RESPONSE REPORT ON THE SANTA ANA PROJECT AND CORANI PROJECT, PUNO, PERU

January 6, 2016

FIGURE 5-1 SILVER PRICE FORECASTS PRODUCED DURING JUNE 2011

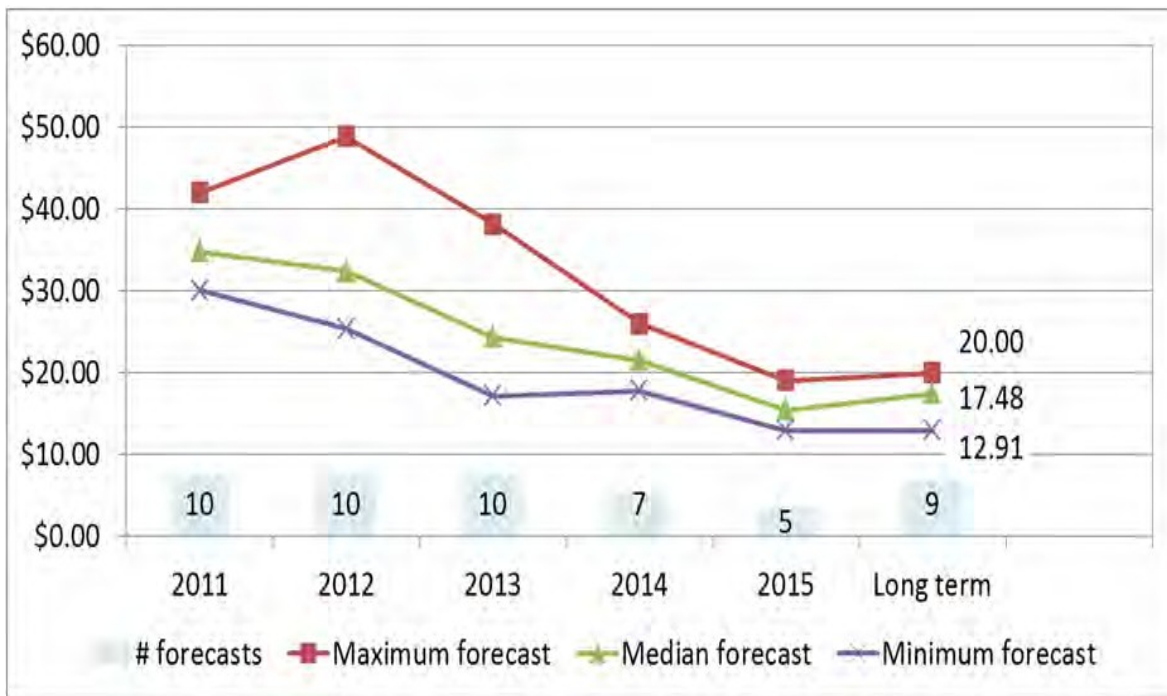
- 82. Figure 6-4 in the SRK report (Figure 5-1) indicates a median long-term consensus average silver price of US\$17.48. This would give support to RPA’s use of US\$16.50 per ounce of silver, and if anything, the silver price used by RPA would be considered conservative. The figure of US\$17.48 per ounce of silver is approximately 35% higher than the US\$13.00 per ounce of silver used for cut-off grades in the 2011 FSU, therefore, it is unclear of SRK’s logic in suggesting that this higher consensus price would “give further support” of a silver price of US\$13.00 per ounce. The silver price of US\$16.50 is closer to US\$17.48 than US\$13.00.

FIGURE 5-3 RELATIONSHIP BETWEEN PARTICLE SIZE AND AG EXTRACTION

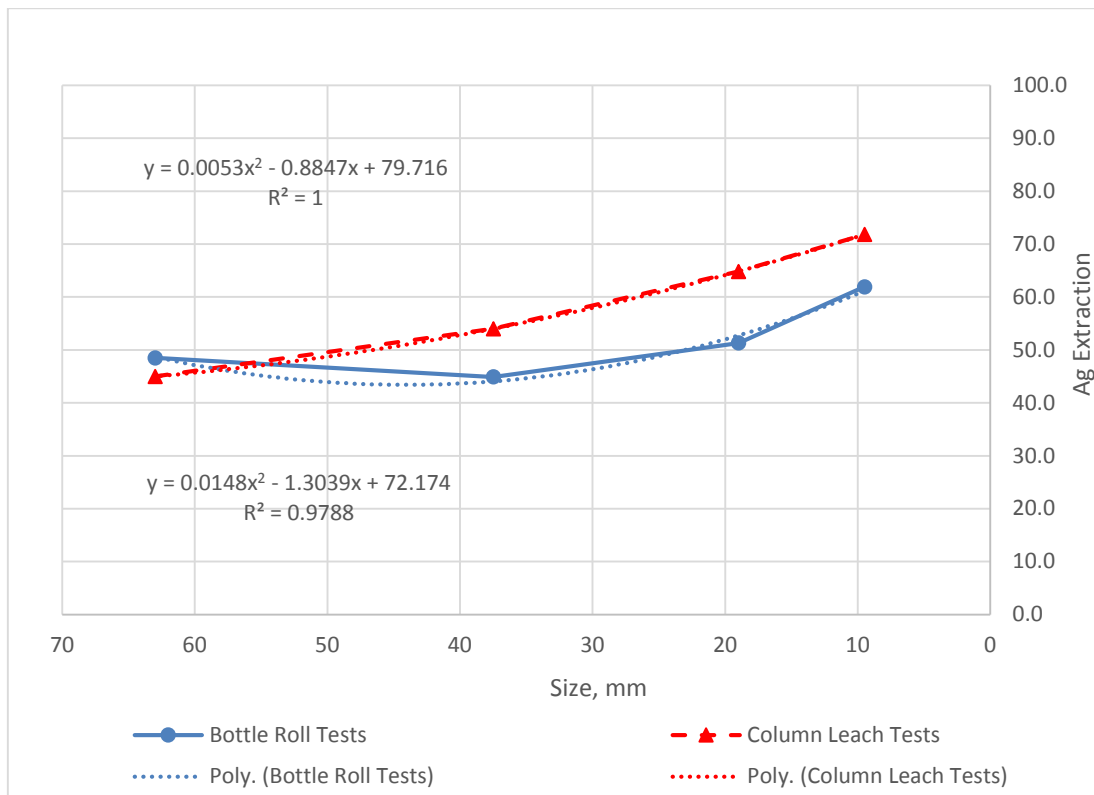
98. Holding recovery to 70% is not realistic based on the data that are available. RPA notes that the silver recovery is highly dependent on the particle size that is processed as shown in Figure 5-3. For both bottle roll tests and column leach tests, the recovery for particle sizes at 9.5 mm is approximately 7% higher than it is for tests conducted using particle sizes of 19 mm, which supports increasing recovery when the ore is crushed to a smaller particle size.
99. The column leach test that was conducted on a sample that was crushed to a nominal particle size of 9.5 mm showed a leach curve that realistically reaches 75% recovery over a 180 day leach period, as shown in Figure 5-4. The period between 101 days and 180 days is extrapolated but appears reasonable based on RPA’s experience with similar projects.

FIGURE 5-4 LEACH CURVE USED AS A BASIS FOR THE FEASIBILITY STUDY

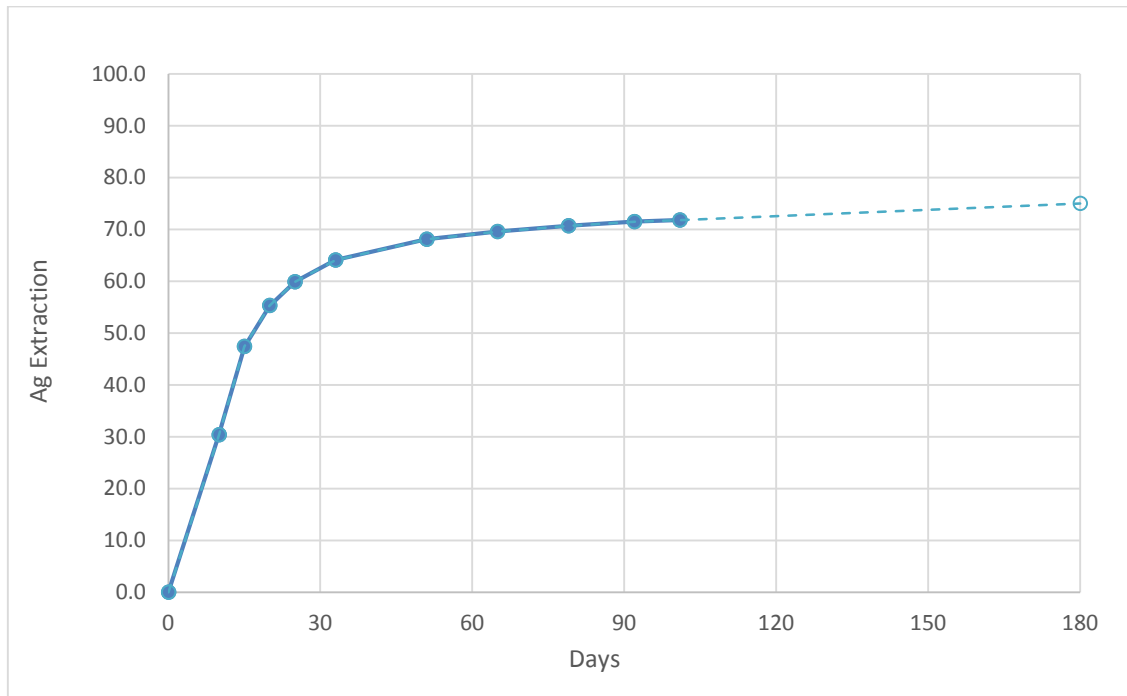
100. Similarly, leach cycles in heap leach pads are based on column test leach curves. The cycle times are commonly adjusted to account for the starting time. That is, there is generally a delay of one or two weeks after ore is stacked on the leach pad until it is placed under leach and saturated with leaching solution, however, to arbitrarily assume that the leach cycle will be lengthened without a detailed analysis of what the time period will be is not realistic and unwarranted.

FIGURE 5-5 CORRELATION BETWEEN AG GRADE AND AG EXTRACTION

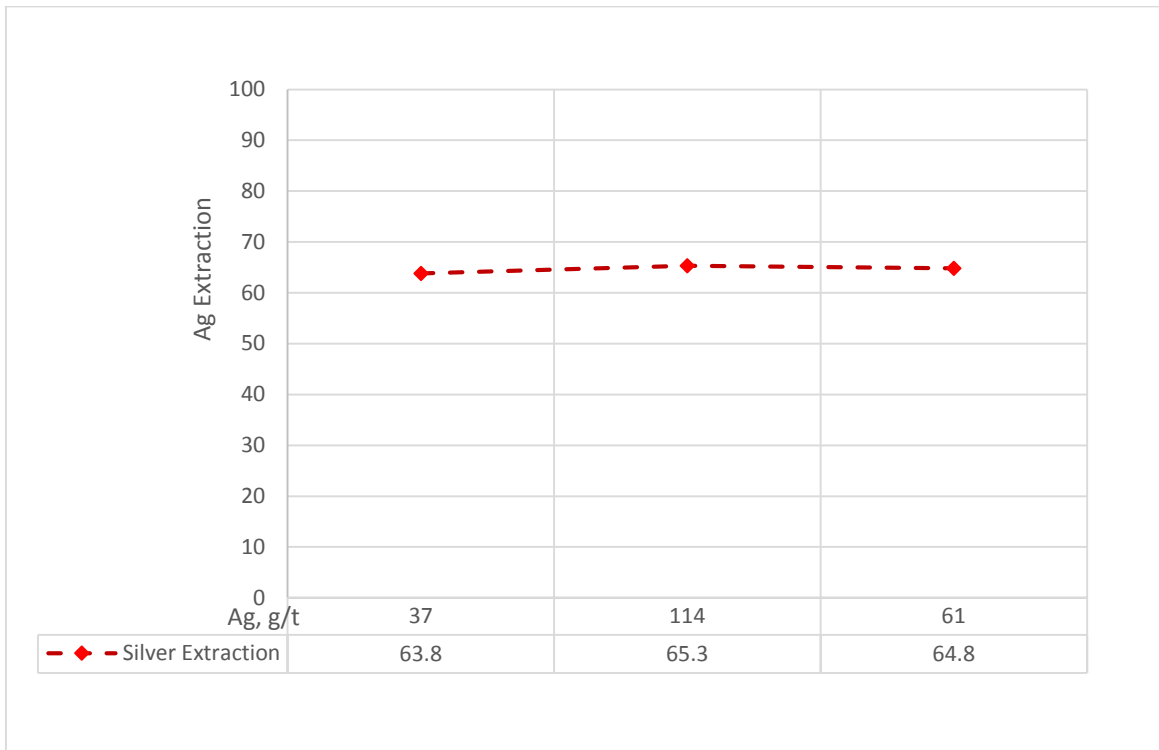
101. There does not appear to be a correlation between the silver head grade and the silver extraction. Two column tests were conducted on a high grade sample and a heap grade sample that were crushed to a nominal particle size of 19 mm. Subsequently, a third column test was conducted using the same particle size. The silver extraction was within 1.5% for all samples even though the silver grade ranged from 37 g/t to 114 g/t as shown in Figure 5-5.

102. The nearly horizontal line on the graph shows that the silver extraction for the sample that had a grade of 38 g/t Ag was approximately 64% and the samples that had grades of 61 g/t Ag and 114 g/t Ag had silver extractions of approximately 65%. This clearly shows that SRK’s claim is incorrect that silver recovery is dependent upon the grade of the material being leached. Based on this data, the estimated recovery is obviously independent of the grade of the material being leached.

FIGURE 5-6 CONSTANCIA PROJECT MILESTONES

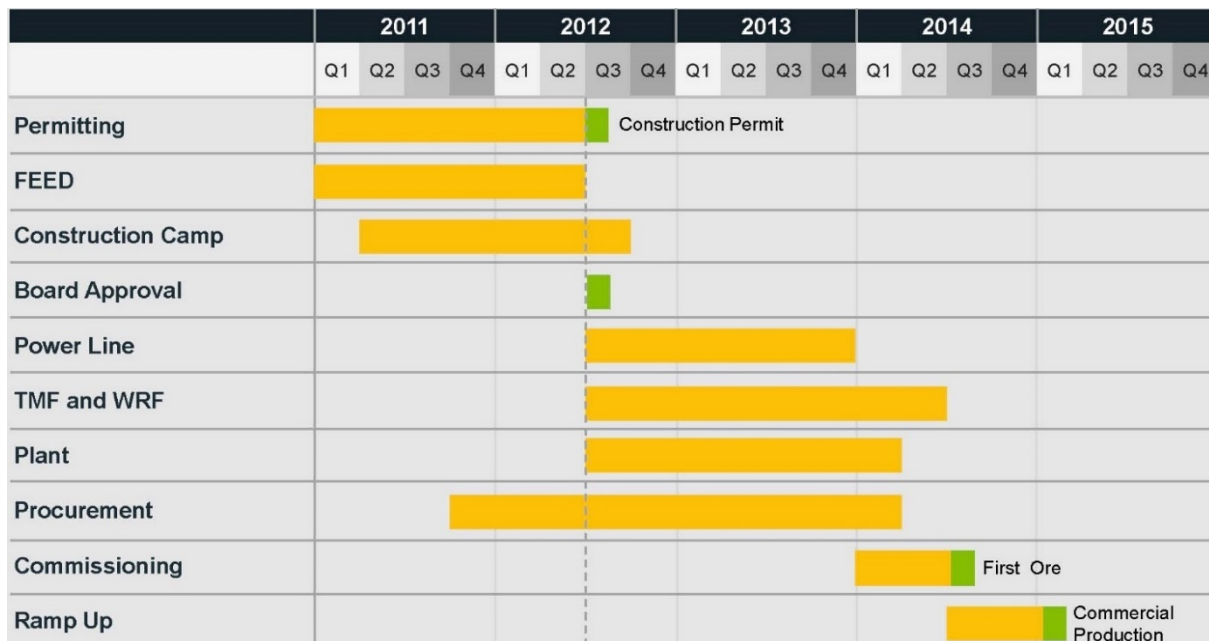
116. The Constancia Project, which is owned and operated by the Hudbay, is an excellent example of a project that met a similar schedule to the one presented for Santa Ana despite the fact that it was a US\$1.3 billion project. Figure 5-6 provides a schedule of the project milestones for Constancia.²⁵

FIGURE 5-7 CORANI LEAD HEAD GRADE VERSUS LEAD RECOVERY TO THE LEAD CONCENTRATE

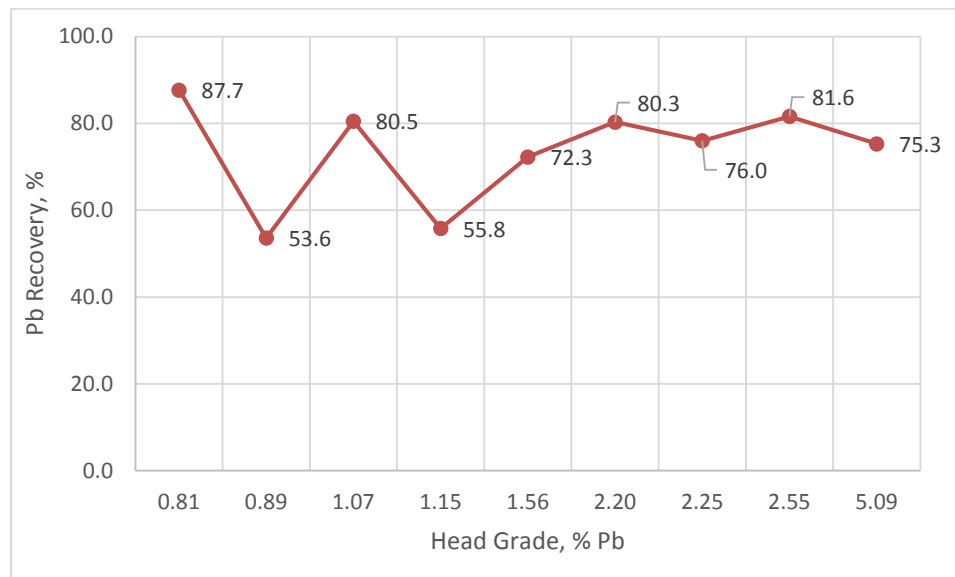
160. Figure 5-7 plots the lead head grade versus the lead recovery for all of the locked cycle tests. The graph shows that the lowest grade sample had the highest recovery, which clearly demonstrates that the SRK assumption that the higher grade samples result in higher recovery is incorrect.

FIGURE 5-8 CORANI SILVER HEAD GRADE VERSUS SILVER RECOVERY INTO THE LEAD CONCENTRATE

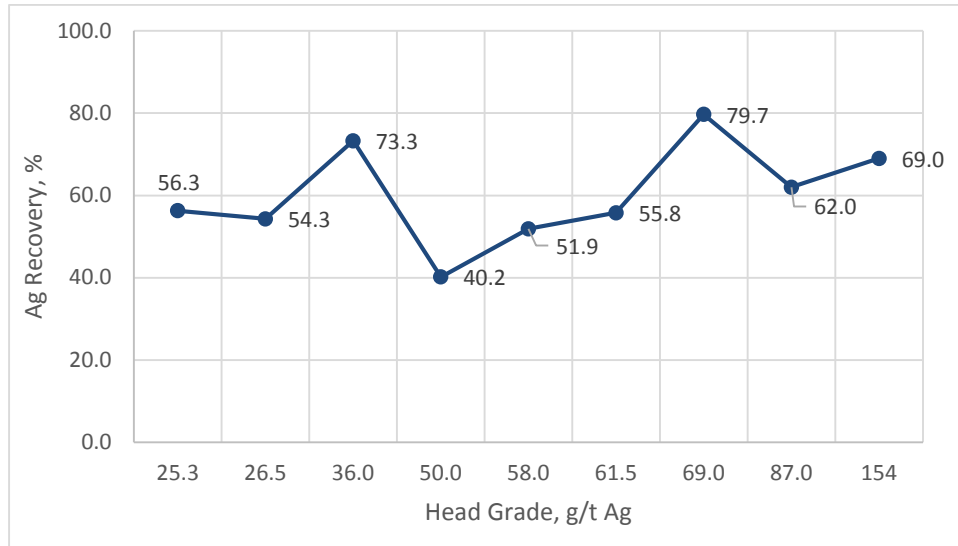
161. A similar plot was completed for the silver grades and recoveries as shown in Figure 5-8.

162. In this case, the answer is not so obvious. The data is inconsistent and erratic but there is definitely not a clear trend that demonstrates that the samples with the highest silver grades result in the highest silver recoveries or vice versa. The highest grade sample does not result in the highest recovery and the lowest grade sample does not result in the lowest recovery which should be true if the SRK assumption was correct.

FIGURE 5-9 CORANI LEAD FEED GRADE VERSUS LEAD RECOVERY TO LEAD CONCENTRATE

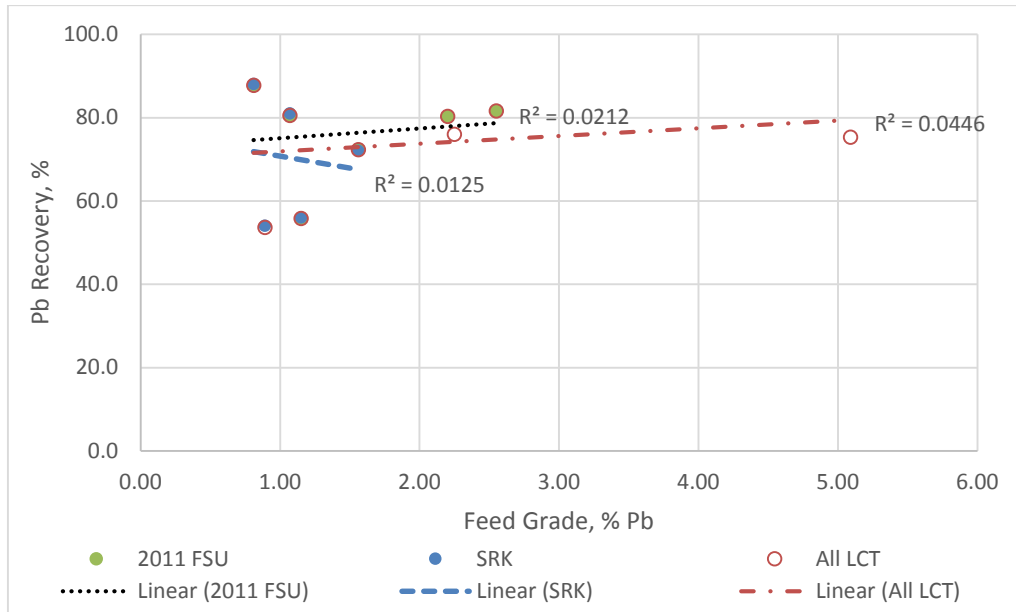
163. RPA then undertook further evaluation of the data. Figure 5-9 presents a graph of three separate data sets.

164. One set of data includes all of the locked cycle test (LCT) data. The linear trend line for the recovery increases slightly as the feed grade increases although it does not indicate that there is a clear relationship between the lead head grade and the recovery. For the FS, M3 used the data from the composites that were not blended and a weighted average to estimate the lead and silver recoveries. The second data set shows this data. Again, the linear trend line shows a slight upward slope as the lead grade increases. The third set of data plotted was the data set used by SRK to justify reducing the lead recovery. The linear trend for this data actually shows that the recovery decreases as the grade increases which does not support the SRK justification for limiting the data set to the samples that have similar grades to the resource grades because they claim the opposite trend.

FIGURE 5-10 CORANI SILVER FEED GRADE VERSUS SILVER RECOVERY TO LEAD CONCENTRATE

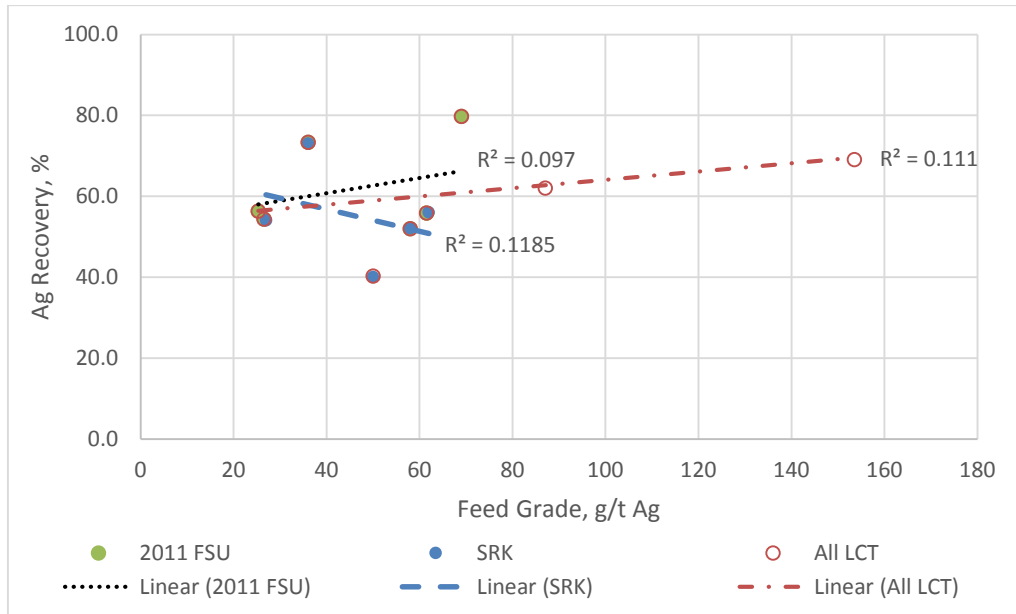
165. Similar graphs were made for the silver data, as shown in Figure 5-10.

166. The results for the silver data are similar to the results for the lead data. The trend lines for all of the locked cycle test data and the data used by M3 show slight upward trends and the data used by SRK shows that the silver recovery trends downward as the silver grade increases which is not consistent with SRK’s assumptions.

FIGURE 5-11 CORANI LEAD HEAD GRADE VS. LEAD RECOVERY FOR TRANSITION ORE LOCKED CYCLE TEST DATA

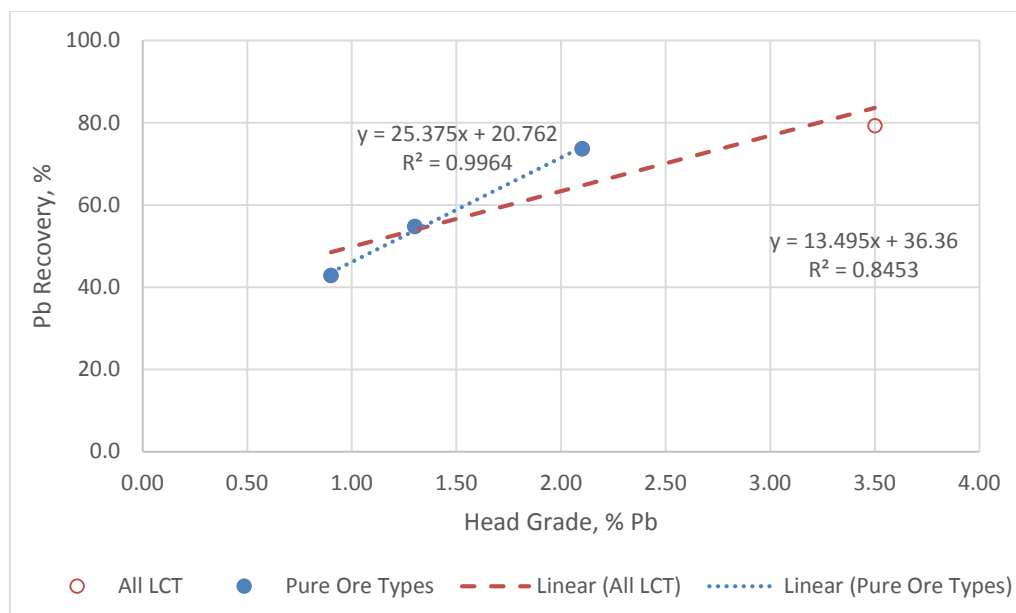
174. The data for lead head grade and lead recovery is plotted in Figure 5-11.

175. Two data sets were evaluated: all of the locked cycle test data and the data for the composite samples that were selected as pure ore types (i.e., composites H, Q, and T). Both data sets show a clear correlation between the lead head grade and the lead recovery. Statistically, the coefficient of determination, also called R-squared, is an indication of the strength of the correlation. A perfect correlation is an R-squared on 1.0. Based on the R-squared for each of the plots, the data for the pure ore types shows the

best mathematical correlation so RPA recommends that the recovery should be calculated using the corresponding equation since it appears to be the most accurate. Using this equation, and the average lead head grade over the life of the mine, the average lead recovery is estimated to be 49.2%, which is not significantly different from the estimated lead recovery provided by SRK. RPA recommends that an estimated lead recovery of 49% be used in place of the average lead recovery used in the 2011 Corani FS (i.e., 51.65%).

FIGURE 5-12 CORANI SILVER HEAD GRADE VS. SILVER RECOVERY FOR TRANSITION ORE LOCKED CYCLE TEST DATA

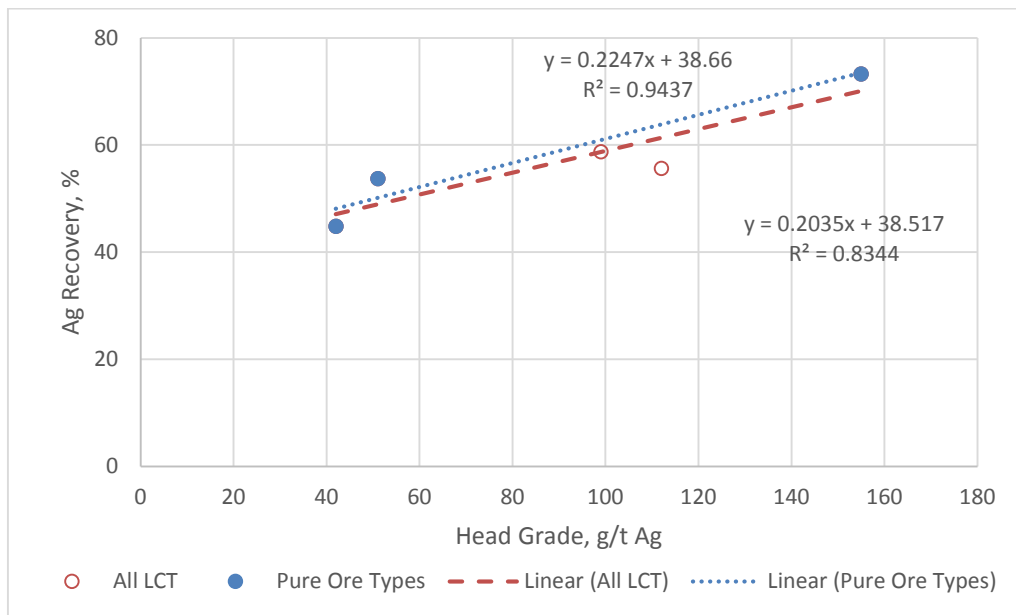
176. The data for the silver head grade and the silver recovery is graphed in Figure 5-12.

177. In this case, the mathematical correlation for the pure ore types, as used to support the FS, is higher which, again, indicates a better data set. If the silver recovery is estimated using this equation and the life of mine (LOM) average silver grade (i.e., 66.16 g/t Ag), the silver recovery is 53.5% which corresponds well to the recovery used in the 2011 Corani FS (i.e., 53.2%). Therefore, RPA agrees with the estimated silver recovery in the 2011 Corani FS and recommends no change be made.

FIGURE 6-1 FSU RESERVE PIT VERSUS EXTENDED LIFE PIT (SECTION VIEW)

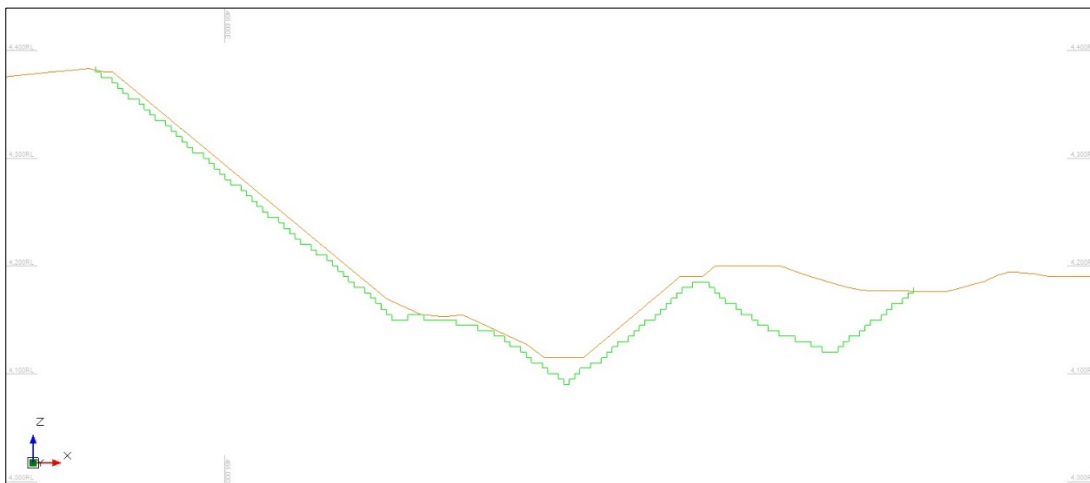
- RPA scheduled the additional Mineral Resources using the same yearly production rate as the FSU and assumed a constant grade and stripping ratio. The reason RPA did this is because it is not realistic to schedule the additional Mineral Resources in isolation from the FSU Reserve Pit. Figure 6-1 shows a cross section of the FSU Reserve Pit versus the Extended Life Whittle Shell created by RPA. Figure 6-2 is a plan view of a typical mine bench of the additional Mineral Resources in the Extended Life Case. The mining bench created by the incremental Mineral Resources (the material located between the Reserve pit and Extended Life Whittle Shell) is thin, discontinuous, and irregularly shaped. The incremental Mineral Resources

simply cannot be scheduled into a reasonable mine plan with sufficient operating room.

- It is precisely for this reason that RPA reported tonnes, grade, and stripping ratios as an average and did not attempt to complete a full design and mine schedule.
